Report of the Strategic Director (Place) to the meeting of the Shipley Area Committee to be held on 24th January 2018 at 6.00pm

Five objections have been received to the advertised Road Hump Notice to install two sets of speed cushions on Park Road near its junction with Lady Lane, Bingley.

This Committee overrule the objections, and the proposed traffic management scheme as shown on drawing no. TDG/THN/103505/CON-1A (attached to this report as Appendix 1) be approved and implemented as formally advertised.

Proposed Traffic Management Scheme As Formally Advertised

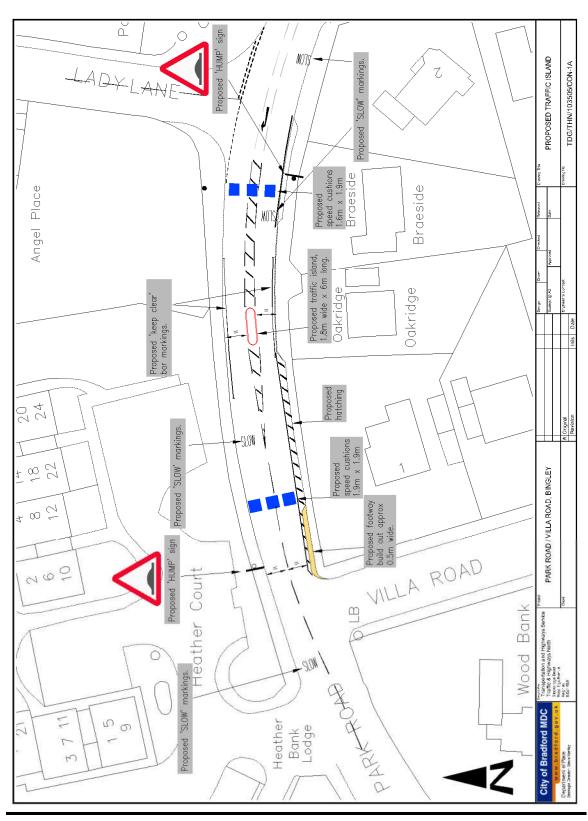
Objector's Concerns (1) **Officer Comments** Objector #1 Road humps affect everyone who The proposed speed cushions would drives over them and not only those be constructed in accordance with national Department for Transport motorists breaking the speed limit. They would cause discomfort to design guidelines and specifications. drivers and passengers and can The specifications seek to avoid user cause spinal injuries. discomfort when the cushions are traversed at an appropriate speed, and the West Yorkshire Ambulance Service has been consulted on the proposal, with no adverse comments having being received. Road trials carried out by the Transport Research Laboratory ... 'have shown that speed cushions are suitable for use as speed control features'. (Traffic Advisory Leaflet 4/94 Speed Cushions). Road humps have been proved to be Research carried out by the Transport bad for the environment, and cause Laboratory Research noise and air pollution. commissioned by the DfT) shows that after the installation of road humps and speed cushions, the maximum noise levels from light vehicles (cars) are reduced. (Traffic Advisory Leaflet 6/96 (Traffic Calming: Traffic and Vehicle Noise) Department for Transport Circular 01/2013 'Setting Local Speed Limits' states (with regards to traffic calmed areas): 'There may be environmental benefits as, generally, driving more slowly at a steady pace will save fuel and reduce pollution, unless an unnecessarily low gear is used'. Road humps create problems for All three Emergency Services have been consulted on the proposals with Emergency Services in achieving their no adverse comments being received. response times. Speed cushions are designed so vehicles can straddle them, thereby helping to ensure that they do not hinder emergency service vehicles.

- Installing speed (safety) cameras would be the best measure here as it would create income and affect only speeding motorists.
- The hump notices were small and poorly advertised and not many people have seen them to object to the scheme.
- This section of Park Road would not meet the current criteria for installing safety cameras. Generating income from safety cameras is not an objective of West Yorkshire Casualty Reduction Partnership – the objective being to improve road safety.
- The proposed speed cushions were advertised in the local press (ie. the Telegraph & Argus) on 20th October 2017 for a three week period.

- Objects to proposed speed cushions, but supports the proposed pedestrian refuge on Park Road.
- Road trials carried out by the Transport Research Laboratory ...'have shown that speed cushions are suitable for use as speed control features'. (Traffic Advisory Leaflet 4/94 Speed Cushions).

- Objects to the proposed speed cushions on Park Road, and supports a crossing facility at this location.
- Objector would not want more humps in Eldwick. Claims the road humps on Warren Lane are not working as they may slow considerate but not inconsiderate drivers.
- Ditto
- The Warren Lane Area is a 20mph zone and has been supported by numerous residents and the local school.

- Road humps in the past have damaged the objector's car despite him/her driving appropriately over them. Believes road humps damage cars even at low speeds. If the proposed road humps on Park Road were implemented, there would be no route without humps between Eldwick and Bingley town centre.

- Has a mini roundabout, zebra crossing, pelican crossing, or scheme similar to the one on Otley Road, Eldwick, using horizontal features, being considered as alternatives to the proposed speed cushions and pedestrian refuge.

- The proposed pedestrian refuge would only assist pedestrians to cross this section of Park Road to a limited extent, and potentially, would create road safety problems for pedestrians standing in the middle of the refuge with traffic passing by on both sides.
- The proposed road humps (speed cushions) will influence responsible drivers, but will not slow down drivers who blatantly ignore speed limits.
- Construction of the proposed traffic island would create disruptive and expensive road works.
- A zebra crossing on this section of Park Road would be cheaper and safer.

I think the main reason for the proposals is to slow traffic on this section of Park Road.

- The scheme proposals are not the best solution for addressing speeding along this section of Park Road. The proposed locations of the road humps (speed cushions) are not appropriate as motorists are driving fast further down Park Road. The proposed humps would create problems in winter for motorist going up Park Road.
- proposals is to help pedestrians cross the road safely. The two proposed sets of speed cushions are intended to encourage vehicles to approach the pedestrian refuge at 30mph or less, thereby reducing the potential for vehicular conflicts with pedestrians.
 - Although the speed cushions are intended to reduce vehicle speeds to 30mph or less, vehicles do not have to stop prior to traversing the cushions. As such, the proposed speed cushions will not create problems for vehicles travelling up Park Road.

There is no legal obligation to place notices on-site. However, in the case of the proposed speed cushions on Park Road, it was considered desirable to erect notices in the interests of giving adequate publicity to the proposed scheme. As such, legal notices were erected within the vicinity of the proposed measures. The notices were A4 size (as is common practice), and provided details of where scheme drawings could be viewed and where objection letters/emails could be submitted.

- There are only two sets of proposed speed cushions, and these are designed to be straddled by vehicles approaching the proposed pedestrian refuge at an appropriate speed. Road humps of varying types have proven to be effective speed reducing vehicles on many of the District's roads.

- All these suggested alternatives have been considered.
- A mini roundabout would not help pedestrians crossing the road and the signing of a mini roundabout would be problematic at this site. Uphill-bound traffic would need to give way to vehicles turning right into Lady Lane which could prove problematic in icy conditions (in terms of being able to set-off again).

- A zebra crossing would cost far in excess of the available scheme budget (largely due to the anti-skid surfacing required on both approach lanes). The relatively steep gradient of Park Road could be problematic for uphill-bound vehicles which had to stop at the zebra crossing (in terms of being able to setoff again).

- A pelican crossing would cost far in excess of the available scheme budget. The relatively steep gradient of Park Road could be problematic for uphill-bound vehicles which had to stop at the pelican crossing in icy conditions (in terms of being able to set-off again).

- Horizontal features were installed along the entire length of Otley Road.
 Treatment on only a specific and relatively short section of Park Road is being proposed, and is therefore much less conducive to the installation of horizontal measures. In addition, the

proposed features are considered more appropriate in meeting the needs of crossing pedestrians than would horizontal features.

- The proposed pedestrian refuge is 1.8m wide, which is sufficiently wide to accommodate a pedestrian with a pushchair waiting on the centre of the refuge.

- The proposed speed cushions are considered an appropriate method of slowing down those drivers whom, without the physical features, would tend to disregard the 30mph speed limit.

- If installed, attempts would be made to keep any traffic disruption to a minimum.
- A zebra crossing would cost far in excess of the available scheme budget (largely due to the anti-skid surfacing required on both approach lanes). The relatively steep gradient of Park Road could be problematic for uphill-bound vehicles which had to stop at the zebra crossing (in terms of being able to set-off again).

- The main objective of these proposals is to help pedestrians cross the road safely. The two proposed sets of speed cushions are intended to encourage vehicles to approach the pedestrian refuge at 30mph or less, thereby reducing the potential for vehicular conflicts with pedestrians.
